Access Compliance Report Public Rights-of-Way (Curb Ramps)

Main Street: ALLEGHENY_DR Cross Street: LORETTA_DR Location: NW

ADA ID: RPAT210930094442 Ramp Type: Type 1 - Perpendicular Diagonal Initial Pass/Fail: Pass Overall Compliance: No Severity Score: 26

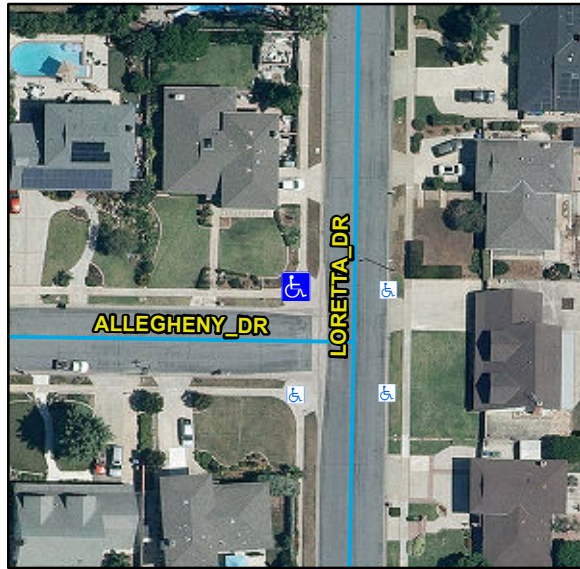
R304.2.2, R304.2.1, R304.2.2-Perp, R304.3.2-Para, R304.5.3, R305, R304.5.4, STD 1115

Remove & Replace Curb Ramp With Two New Directional Ramps or Equivalent. Remove & Replace Gutter.
